ADDENDUM NO. 1

ISSUE DATE: **September 14, 2026**

RE: **BIRGE L&S 4TH FLOOR BIOLOGY RISE LAB RENOVATION
UNIVERSITY OF WISCONSIN-MADISON
MADISON, WISCONSIN**

UW-Institution Project No. 0054-2507

1 DEMOLITION PLAN - FOURTH FLOOR

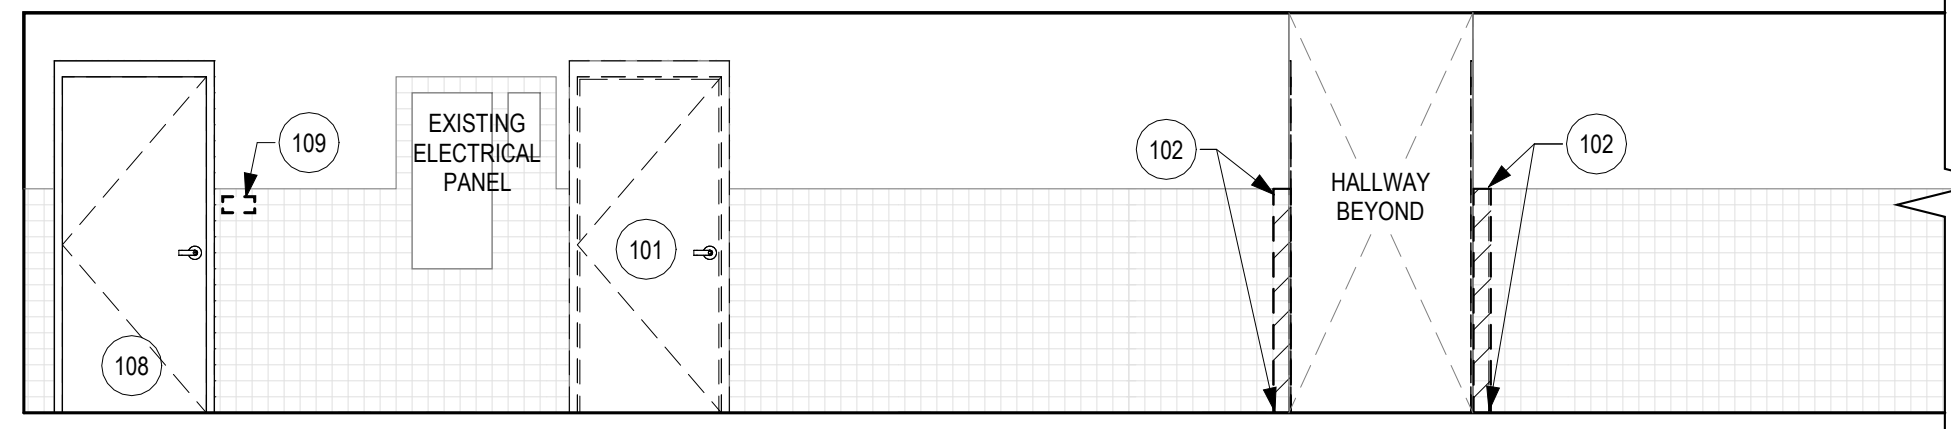
1. Sheet A101 – DEMOLITION PLAN – LEVEL 04 FOR INFORMATION ONLY
 - a. ADD General Demolition Notes To Contractor, Note 10 (For Information Only).
2. Sheet E400 – PROPOSED ELECTRICAL CONDUIT ROUTING FOR INFORMATION ONLY
 - a. ADD MDP-1 Images for Reference (For Information Only).
3. Sheet H100 – ASBESTOS ABATEMENT PLAN – LEVEL 04
 - a. REVISE areas to be abated.
